SUBJECT: **Addenda No. 1**
BEREA BRANCH LIBRARY
Granville County

FROM: Ramsay, Burgin, Smith Architects, Inc.
225 North Main Street, Suite 501
Salisbury, NC 28144

GRANVILLE COUNTY
BEREA BRANCH LIBRARY
1211 US Highway 158
Oxford, NC 27565
ADDENDUM #1
ALTERNATE OPTION
CLAD EXISTING WINDOW FRAME

SHEET NO. **ABD-1**
OF 1

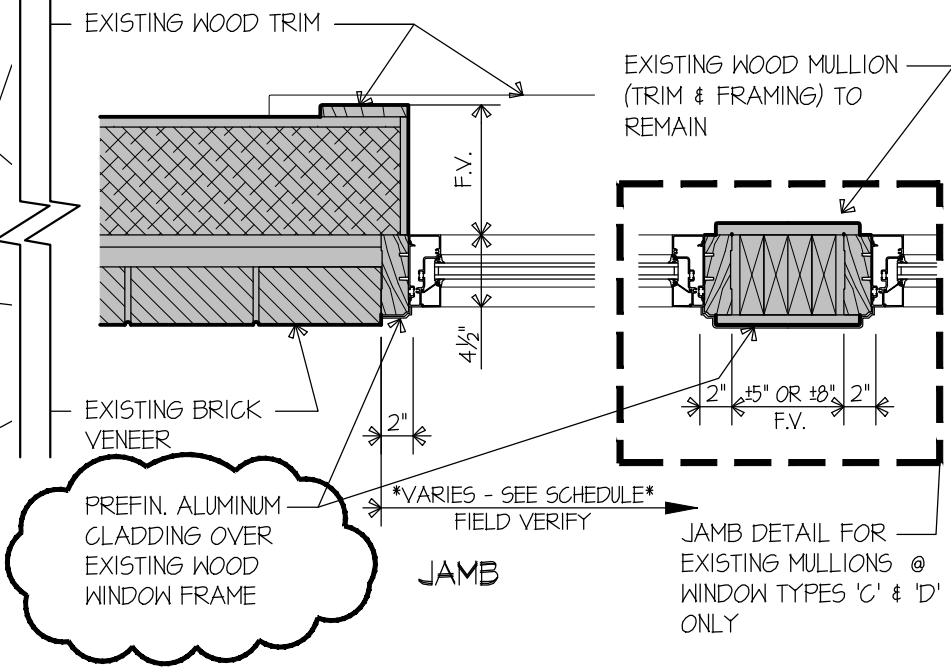
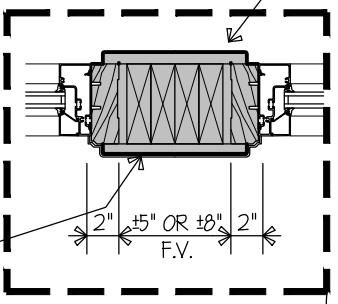
Item #18: Reference Window Details A4-10, Alternate. See attached Architectural Bulletin Drawing ABD-1. Also see Item #10 in this Addendum:

Note revised 'Head' and 'Jamb' Details. Wrap existing wood window frame with prefinished aluminum cladding as part of Alternate #3 work.

REVISE
A4-10
